**UPDATED TRAFFIC AND PARKING IMPACT ASSESSMENT OF
THE PROPOSED CHILD CARE CENTRE
AT 4B AND 8 CHARLTON AVENUE, TURRAMURRA**

Development Type: Child Care Centre

Site Address: 4B and 8 Charlton Avenue, Turramurra

Document reference: 250823.01FA

FIGURE 4: INDICATIVE 12.5M LENGTH HRV SWEEP PATH

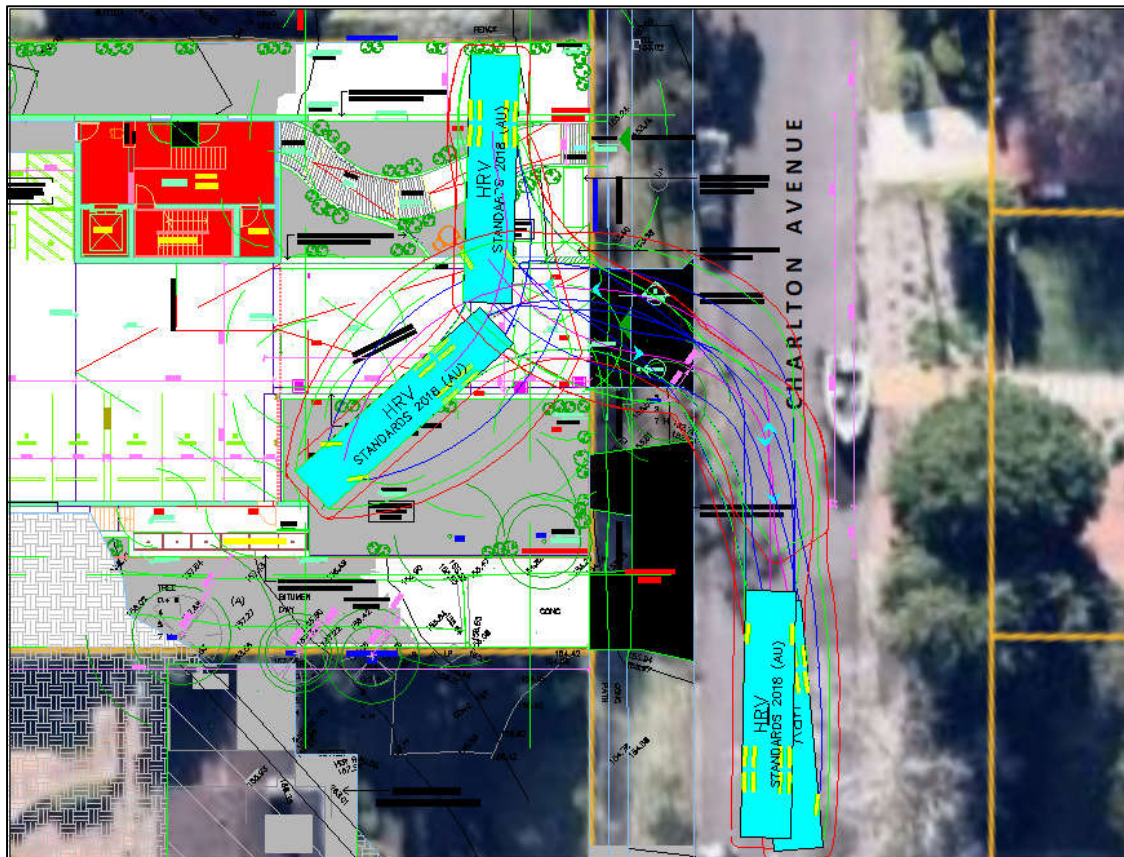
12. No indicative construction traffic management plan has been submitted (required under Council’s DA Guide). Plan is to show the largest vehicle to be used entering and exiting the site for the demolition, excavation and construction stages, stockpiles and all necessary tree protection fencing. Consultation with the project arborist is recommended.

MTE Response: A Construction Traffic Management Plan (CTMP) is typically detailed after the Development Application stage prior to construction and as part of a consent condition, where a builder would be engaged. An indicative CTMP for the DA stage has been provided in **Section 6**.

It has been advised that a construction plan with stockpiles and tree protection fencing details will not be available prior to a builder being engaged at the post DA stage. However, it has been advised that it is expected that there will be sediment control fencing on the property boundary, no stockpiles within the “SRZ” of trees in the front setback and stockpiles to be located roughly near the building line.

SHEET NAME
LOWER GROUND FLOOR PLAN

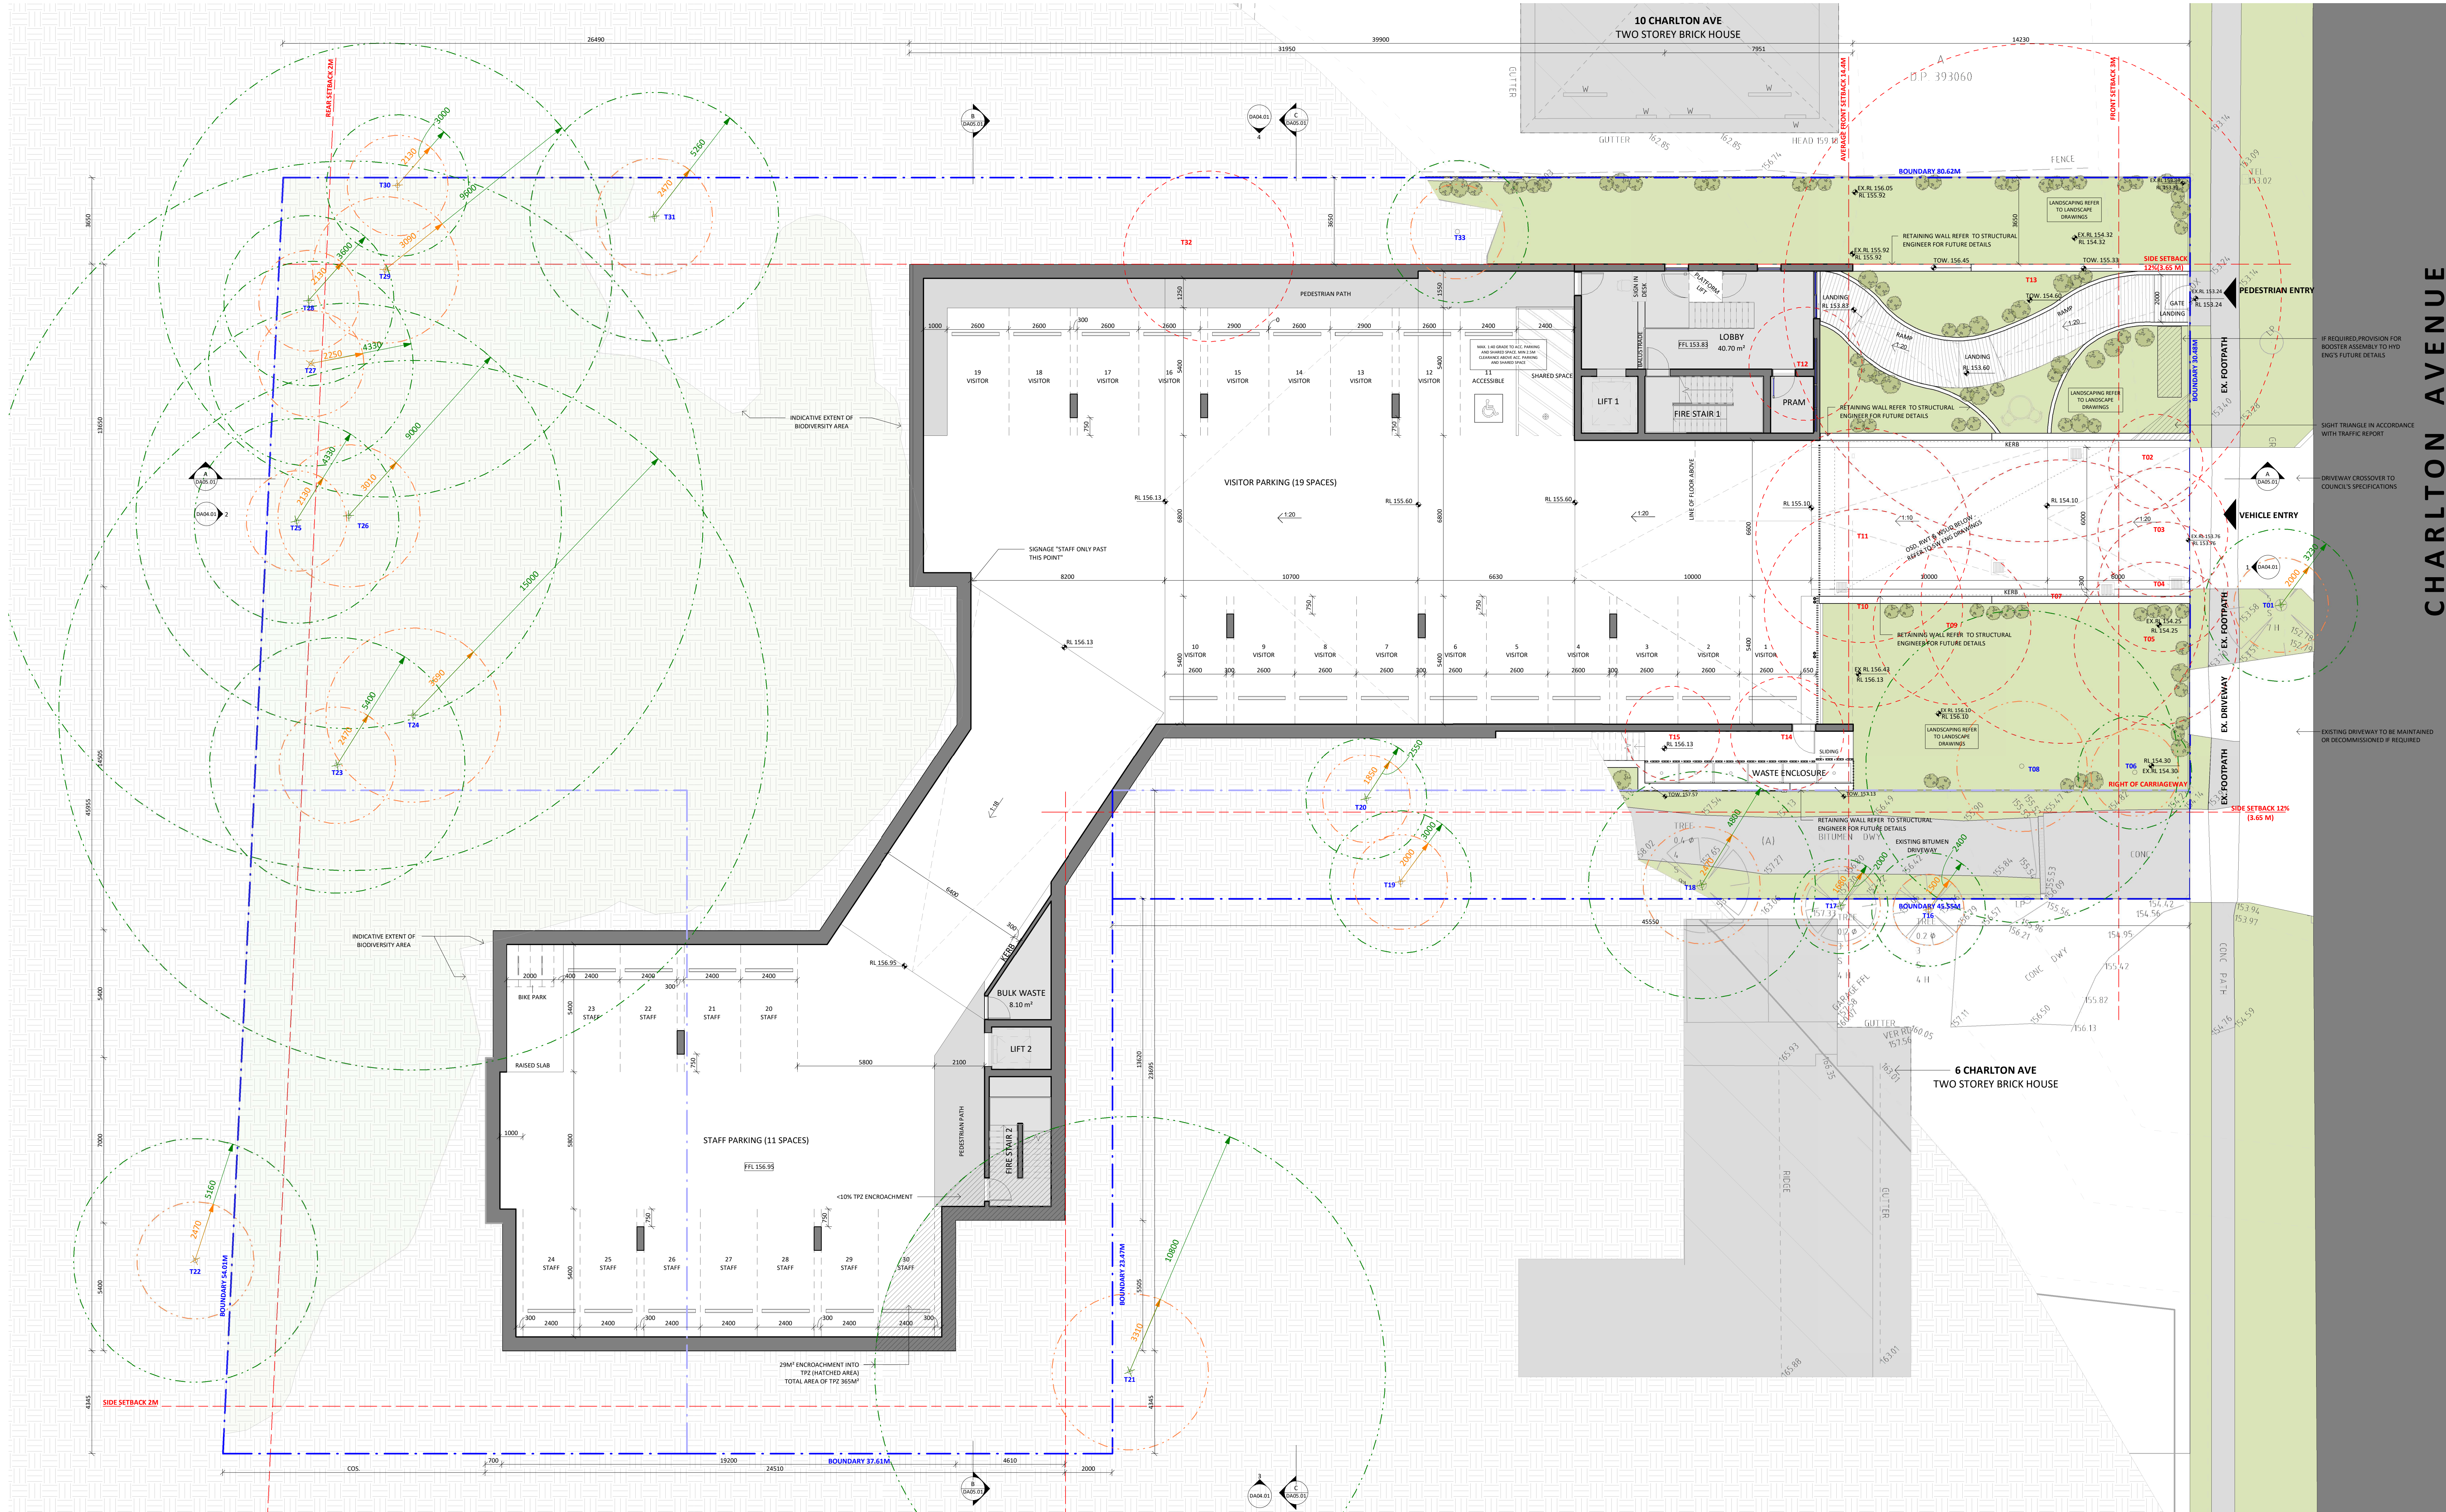
7. There are 9 visitor car parking spaces provided outside the basement, which does not comply with Control 1 of Part 10.3 of the Ku-ring-gai DCP. The 9 car parking spaces must be located in the basement or removed.

9. EV readiness is to be provided for all car parking spaces within the development and depicted on the plans.

10. The 2 bicycle parking devices within the staff car park in the basement are to be provided in accordance with the appropriate security level specified in AS2890.3.

11. Bicycle parking in car park areas are to be on a raised slab (which extends out to the manoeuvring vehicle’s wheel position) or other similar treatment, to protect bicycles and riders from manoeuvring vehicles.

MTE Response: The plans of the proposed development have been updated and are reproduced in **Annexure A** for reference. The nine (9) car parking spaces provided outside the basement have been removed with the proposed scale of the child care centre reduced from a maximum of 140 children at the centre to a maximum of 120 children now proposed for the centre. The proposed 30 car parking spaces complies with the KDCP 2024 minimum requirement of 29 car parking spaces.

MTE Response: This is to be addressed by others. Any EV charging infrastructure shall be provided outside of the vehicular design envelope of the proposed car parking spaces.

MTE Response: The appropriate security level for staff bicycle parking in accordance with AS2890.3:2015 is a Class B facility. The level requires “a secure structure, protected from the weather, containing bicycle parking devices that allow users to lock the bicycle frame and both wheels” as per Table 1.1 of AS2890.3:2015. The proposed undercover parking area of the proposed development, where the bicycle parking is provided, is secured by a sliding shutter door. Additionally, the proposed devices for the bicycle parking spaces are a standard rail which allow users to lock the bicycle frame and both wheels. Therefore, the proposed bicycle parking spaces are provided with the appropriate security level.

MTE Response: The updated plans (provided in **Annexure A**) detail the proposed bicycle parking spaces to be provided on a raised slab, satisfying this request.

SRV ACCESSING UNDERCOVER PARKING MODULE

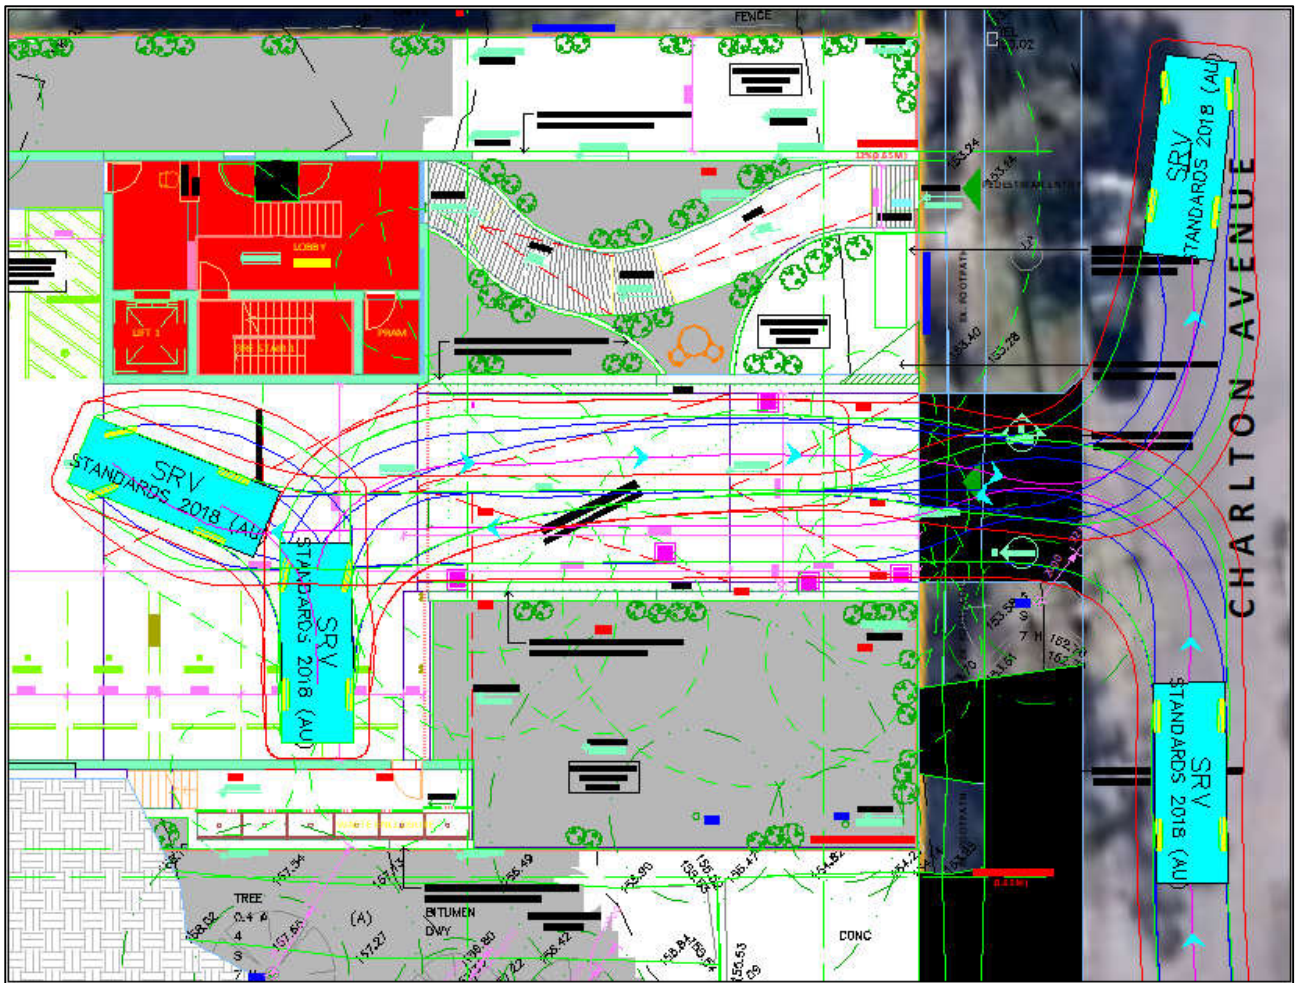
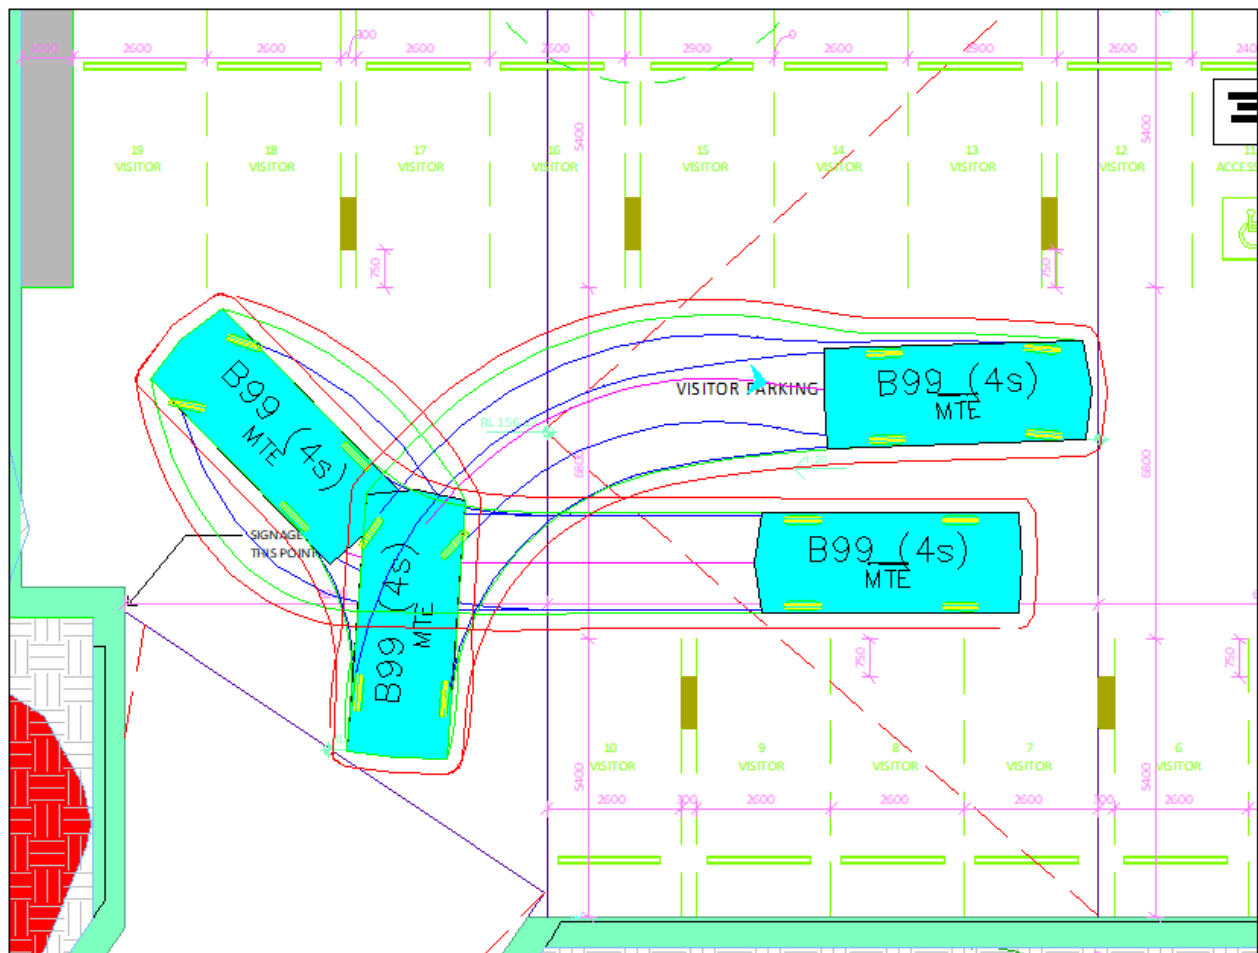
8. In light of the non-compliance of the at-grade car parking in the front setback noted above, and the reliance that waste collection places on this space, clarification is required as to the alternative waste collection arrangements.

MTE Response: Waste collection is proposed to be undertaken within the undercover car parking area of the proposed development. via a collection vehicle of a size up to and including a 6.4m length Small Rigid Vehicle (SRV) in accordance with AS2890.2:2018. The waste collection will be managed such that the waste will be collected outside of operating hours of the child care centre where the visitor car parking spaces within the at-grade car parking area will be vacant. Swept path testing has been undertaken to assess the ability of the design vehicle to access the site, with results reproduced in **Annexure D**. The results indicate that an SRV can successfully access the at-grade carparking area and exit the site in a forward direction. Therefore, the proposed waste collection operation is considered acceptable.
